# POST-OCCUPANCY EVALUATION REPORT

## GOLDEN SANDS SCHOOL

PAPAMOĀ | JULY 2015

Internal and External Doors

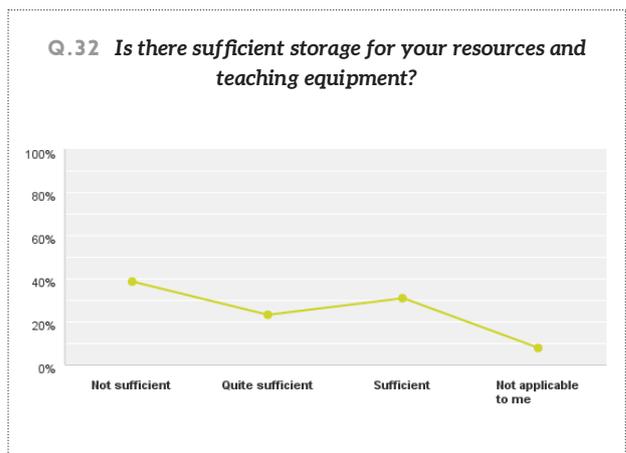
During the interviews it was stated that the interior sliding doors were too heavy for the junior users and that the bottom guides continually required realignment and on-going management by the school. Stage One had a number or external doors that were too heavy for the students to operate safely. Staff stated that the doors which swing 180° are of most concern as the wind can blow them open and it can make the learning environment uncomfortable. Due to these issues, the doors in Stage Two were made smaller and lighter. However, during the interviews it was stated that these doors were "too lightweight" for their purpose and that they "derailed" frequently. It was evident during the evaluation that the school had made attempts to improve the performance of the internal sliding doors by installing additional guides, however, this will be an ongoing maintenance issue for the school. Consideration should be given to this by future design teams.

2. The internal sliding door tracks, which divide the Stage One studio spaces from the withdrawal and collaboration spaces, frequently misalign. These doors were designed to slide together to meet in the corner, however more robust commercial tracks and/or hardware are required. It is recommended that the internal sliding doors are reviewed by a specialist in detail so that robust recommendations and guidelines can be provided.

3. It is recommended that all external doors which swing 180 degrees should be removed and replaced with robust single hinged commercial doors with appropriate closing mechanisms, thresholds and hardware.

Multi-purpose hall ceiling

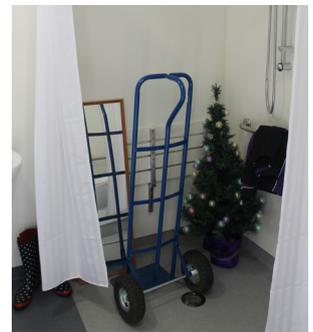
The evaluation team noted that the materials used on the hall’s ceiling were not as robust as they could be, and unprotected services hung from the ceiling. This will require on-going maintenance from the school. The evaluation team recommends a more robust specification of materials and protection for the ceiling fittings in these types of situations.

Stage One air grills between spaces

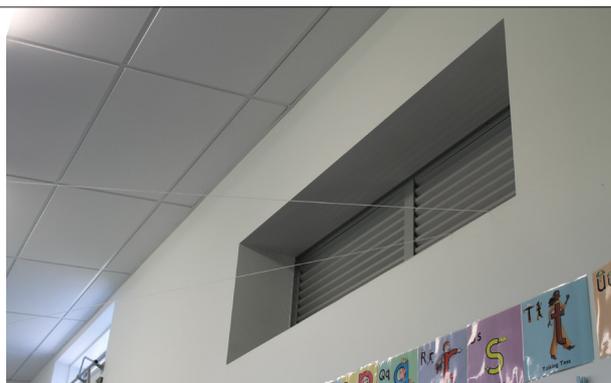
The Stage One learning centre has a wider footprint than Stage Two and is designed as a cluster of rooms. There are two or more rooms positioned next to each other, which will minimise the effectiveness of cross-ventilation strategies. To assist with airflow between the rooms, air grills between the collaboration space and the studio spaces were positioned at a high level. 46% of those surveyed stated that the air in the learning environment during winter was either 'quite stale' or 'very stale' (see graph Q18).

Stage One central collaboration space

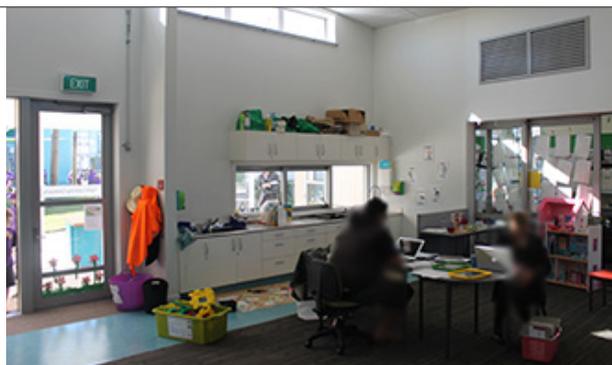
The Stage One central collaboration space was identified during the interviews as “being noisy”. Survey responses from staff also stated that “the acoustics in the Stage One central collaboration space were inadequate”. The evaluation team noted that the space had high ceilings (higher than 3 metres) and glass surfaces on three sides which limited the amount of acoustic wall panels. It was also evident during the evaluation that the doors were too heavy to move for the students with tracks experiencing wear and tear. Further investigation of this space is recommended.

1. Occupants of the central collaborative space in Stage One expressed that the acoustics were poor. The evaluation team recommends that an acoustic engineer undertake diagnostic testing under normal working conditions to provide a better understanding of this issue. In the least, additional pin-board panels should be installed.
